PROPOSED IMPROVEMENT BRIDGE PROJECT TOWN OF WALLINGFORD COUNTY OF RUTLAND

PROJECT DESCRIPTION: REHABILITATE AND ASSEMBLE HISTORIC TRUSS OVER OTTER CREEK AT THE WALLINGFORD TOWN PARK.

The following Structural Steel shop drawing details for the above project (General Contractor – Renaud Bros , Inc) have been reviewed and are being returned herewith

TITLE: Wallingford Bridge Rehab
LOCATION: Wallingford, VT
OWNER: Tru
DRAWING: Truss Type 1 General Notes & Drawings
DRAWN BY: JED JOB CONTACT: Erick Foster State of VT
CHECKED BY: JED/AD DATE: 4.30.09

JOB: WALLINGFORD BRIDGE		PART	
WALLINGFORD, VT			
STL GR: M270-50 UNO	DRWN BY: EG	DATE: 5-11-09	SHT:
BOLTS: 3/4" DIA. M164-I GALV	HOLES: 13/16 UNO	JOB NO:	p9

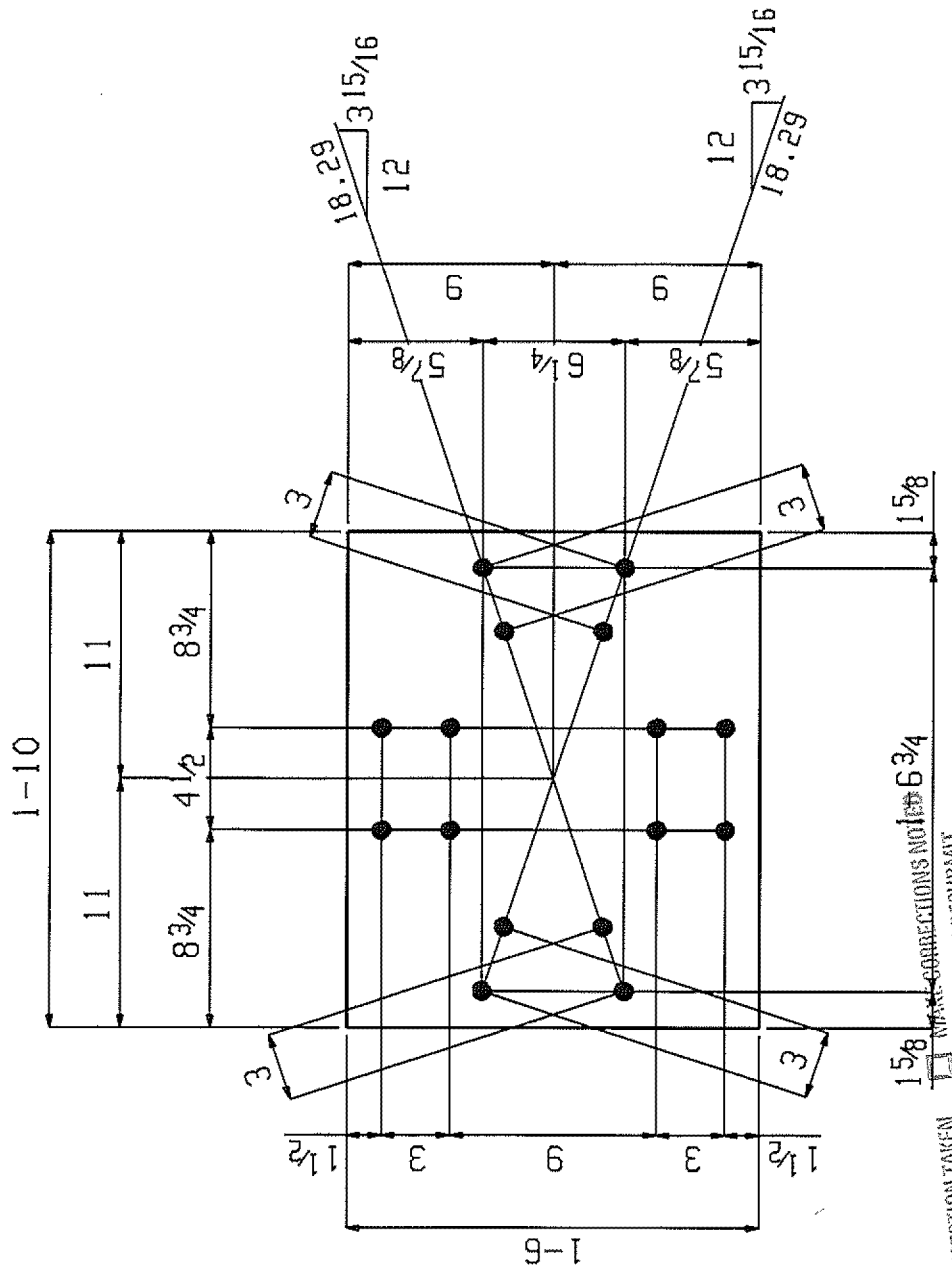
15/8 MARK CORRECTIONS NOTED 6 3/4
